Overview: Production error in version 1.0 harnesses; The immobilizer wire (orange/black) is in pin position #4 instead of pin position #5. Although an effort to correct the issue was made, some quantity of harnesses did get shipped before the issue was spotted. We are advising to inspect the harness BLADE connector before attempting to install harness or program the module. This issue is not known to affect the version 2 harnesses, which require no modification.

FTI-STP1: Notas de instalación y configuración

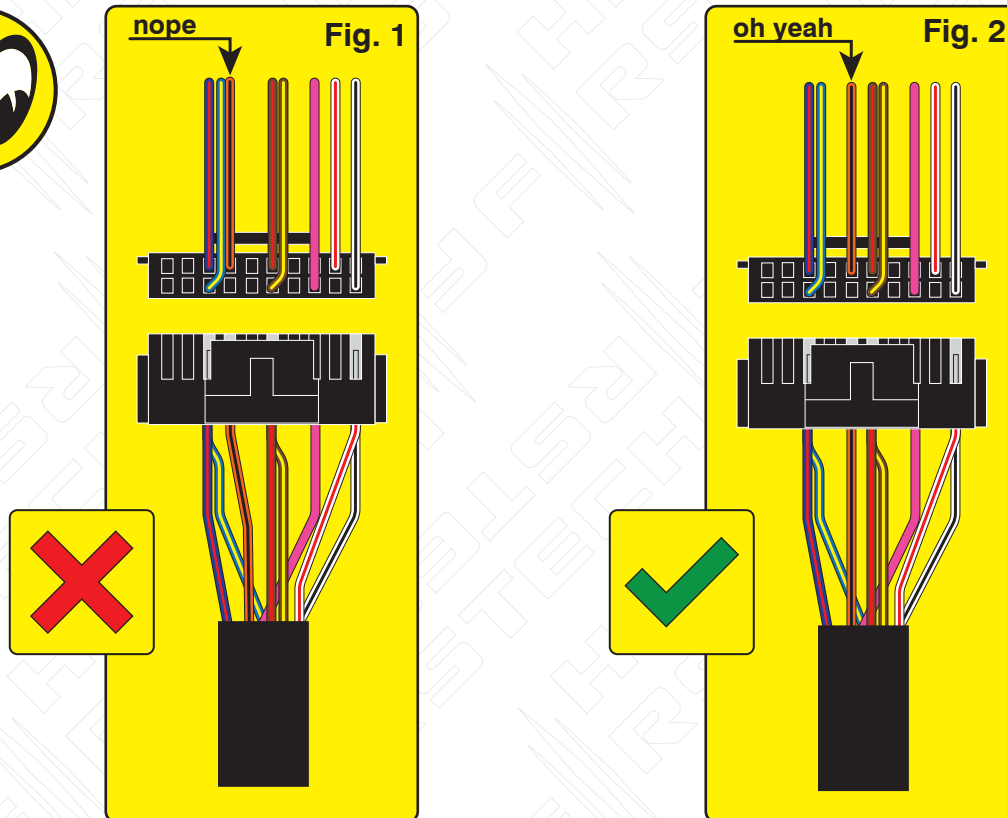
Issue: Module fails to program correctly to vehicle, does not allow the vehicle to be remote started.

Correction: Step 1.) Locate the orange/black wire and confirm whether it is positioned as illustrated in Fig. 1 or Fig. 2. If the wire is as illustrated in Fig.1, proceed with Step 2 through 5 and complete the repair procedure outlined, if the wire is as illustrated in Fig. 2, correction is not necessary, proceed with harness installation and module programming.

Step 2.) Using a pick, lightly depress the catch that secures the terminal in the housing then remove the wire and terminal from the housing.

Step 3.) Using a fine tip razor or utility knife, insert the blade beneath the terminal catch and raise it slightly, so that it can be reused to secure the terminal when reinserted into the BLADE connector housing.

Step 4.) Refer to Fig. 2 for correct position of the orange/black wire (next to brown/red) then reinsert the terminal, pressing lightly until the catch 'snaps' into place, securing the terminal in the connector housing.

MODIFICACIÓN REQUERIDA PARA APLICACIONES A/T, SÓLO CON ARNÉS v 1.0

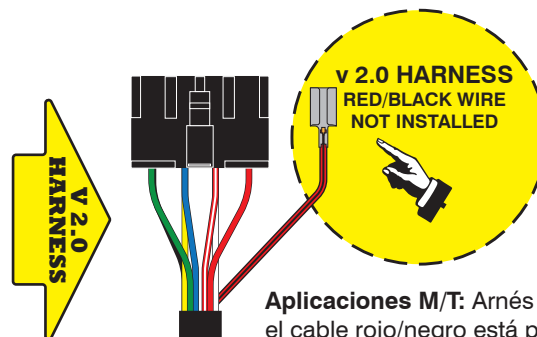
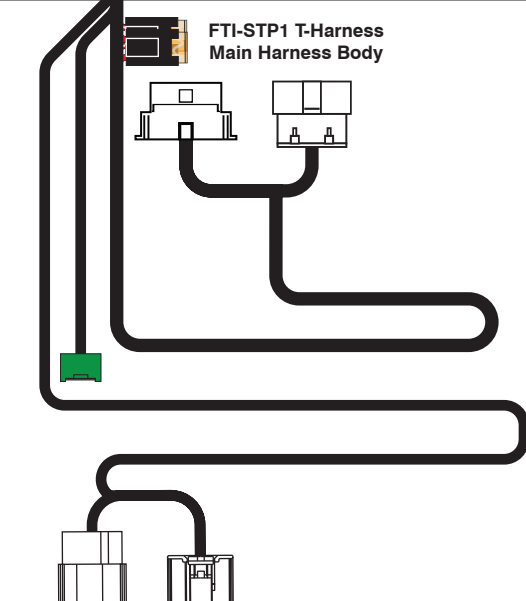
Problema: El arnés en T FTI-STP1 ha sido diseñado para ser compatible con A/T (transmisión automática) y M/T (manual transmisión), pero debido a un descuido en las primeras ejecuciones de producción, la selección se estableció por defecto en el modo M/T.

El uso de un arnés configurado para una aplicación M/T, en un vehículo equipado con A/T, podría provocar daños en el módulo del vehículo, se recomienda que el arnés vuelva al modo A/T antes de la instalación en vehículos equipados con transmisión automática.

Corrección: Localice el cable rojo/negro (+ embrague) proporcionado en el conector CN1 del conjunto del arnés principal. Corte el cable rojo/negro, ya sea al ras del conector CN1 o dejando suficiente cable expuesto para que pueda aislar y asegure los extremos del cable que quedan después del corte. Aísle cada uno de los extremos restantes del cable rojo/negro y asegúrelos para evitar cualquier posibilidad de cortocircuito. Si el cable rojo/negro ya ha sido desconectado, ninguna modificación adicional se requiere para aplicaciones A/T

NO SE REQUIERE MODIFICACIÓN CUANDO SE UTILIZA FTI-STP1 (v 1.0) ARNÉS EN APLICACIONES M/T, O CUANDO UTILICE EL ARNÉS FTI-STP1 (v 2.0)

Aplicaciones M/T: Arnés versión 2.0, el cable rojo/negro está pegado al arnés principal cuando se envía, y debe instalarse en el CN1 conector cuando está instalado.

Aplicaciones A/T: Deje el cable rojo/negro pegado al arnés, no es necesario para aplicaciones A/T
